## Service Bulletin

### Introduction of new Generator ATP Software v7R1b78

<b>Title:</b>	DX-D 100 - Service Bulletin No. 63 - Introduction of new Generator ATP Software v7R1b78
<b>Livelink ID:</b>	47923613
<b>Version#:</b>	6
<b>Version Date:</b>	2014-12-17 04:40 PM CET
<b>Status:</b>	Approved on 2015-02-10 12:32 PM CET
<b>Owner:</b>	Annette Peters (awtso)
<b>Created By:</b>	Annette Peters (awtso)
<b>Created Date:</b>	2014-12-04 04:09 PM CET
<b>PDF Creation Date:</b>	2015-02-10 12:32 PM CET

Figure 6

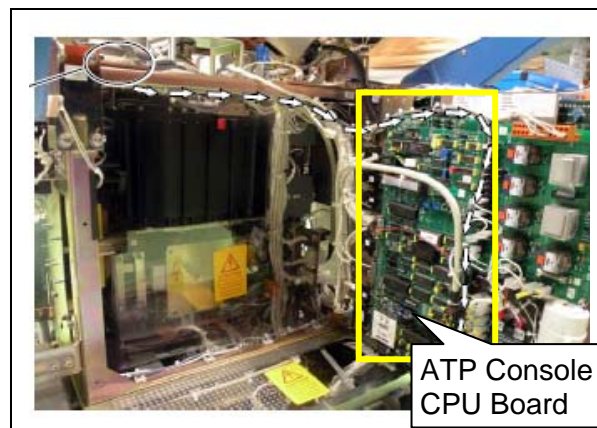
- (1) Remove the front cover.
- (2) Open the generator module front door by removing the two Allen screws. The ATP console CPU board is placed at the generator module front door.
- (3) Remove the U24 EPROM on the ATP Console CPU with a chip extractor.
- (4) Mount the new U24 EPROM with software version v7R1b78.

Figure 7

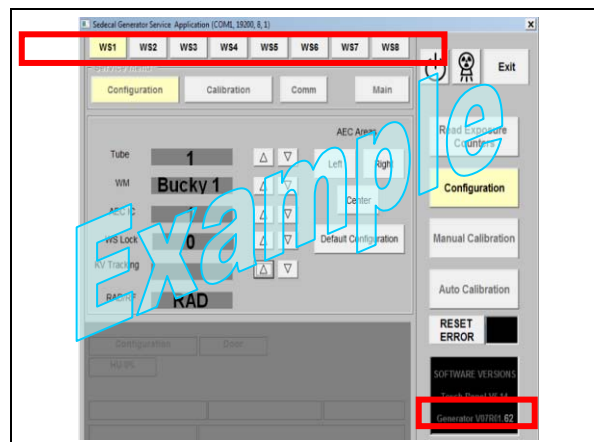
- (1) Switch on the generator.
  - (2) On the NX, start the Techserv software.
- Error 10 appears.
- (3) Click **RESET ERROR**
- Error 98 appears.
- (4) Click **RESET ERROR**
  - (5) Click **Configuration**
  - (6) Check the software version.  
Correct version: Generator v7R1b78
